D/DRC Case

1116 Woodrow Street

DESIGN/DEVELOPMENT REVIEW COMMISSION
DESIGN REVIEW DISTRICT
CONSENT AGENDA
EVALUATION SHEET
Case # 2

NATURE OF REQUEST: Request Certificate of Design Approval for exterior changes and preliminary certification for the Bailey Bill

Staff photos of porch ceiling and porch floor in disrepair

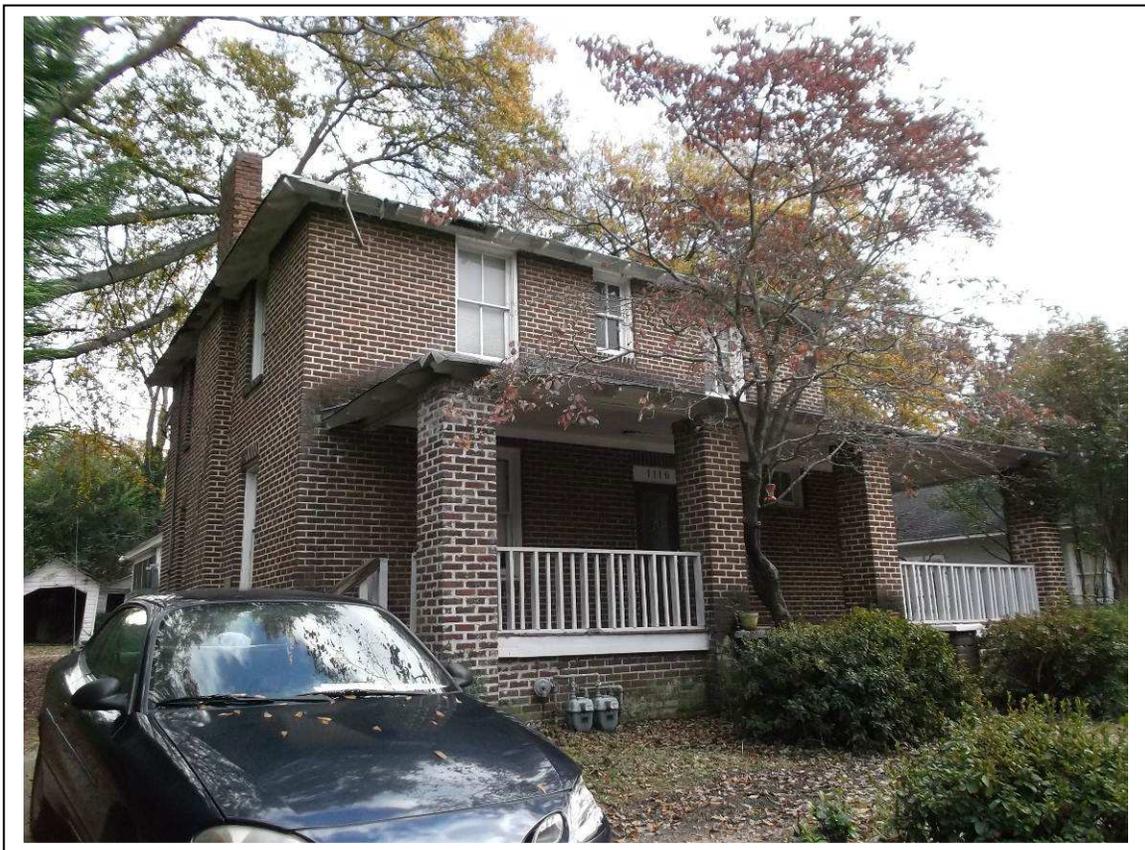
The porch flooring is somewhat deteriorated due to the water and termite damage in the floor joists, and part of the porch floor has previously been replaced. The proposal is to replace the porch floor with the exact same kind of flooring, which is the typical tongue-and-groove 1"x3" dimensional wood.

The historic character will be retained and preserved. There is some removal of historic material on the porch floor and a few pieces of the porch ceiling due to damage. The porch floor has already been compromised by new infill pieces and rot. The beadboard porch ceiling will be carefully repaired with replacement of only a few boards that show disrepair.

Staff finds that the proposal meets Section 7 of the guidelines and recommends a Certificate of Design Approval with all details deferred to staff.
